CLIENT
HIGHCASTLE HOMES

PROJECT/LOCATION
RIVERWALK, PHASE 2
BRAMPTON, ON

DRAWING
SITE PLAN

LOT NO. 20 REGISTERED PLAN

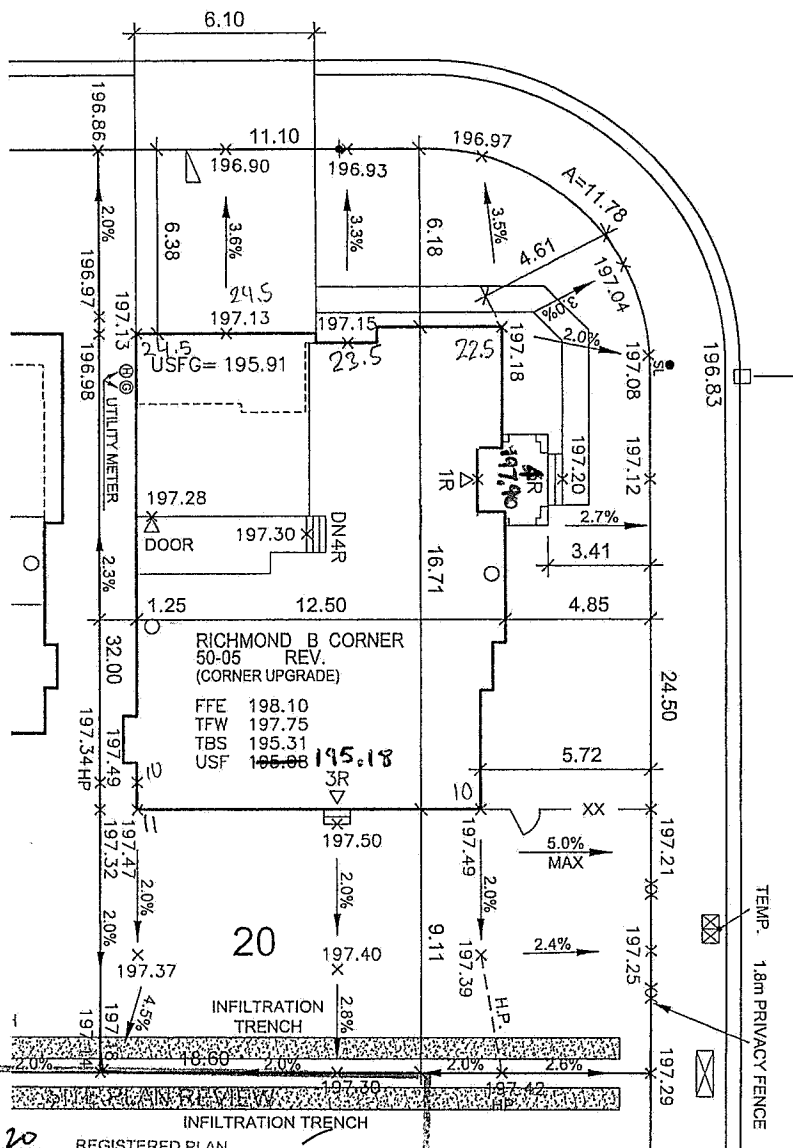
THE PROPOSED LOT GRADING AND DRAINAGE IS APPROVED AS BEING IN CONFORMITY WITH THE OVERALL APPROVED GRADING PLANS FOR THE SUBDIVISION.

NOTE:
RLCB LEAD PRESENT, CAUTION WHEN EXCAVATING.
BUILDER TO VERIFY ADEQUACY OF FOUNDING SOILS
ADJACENT TO RLCB LEADS.
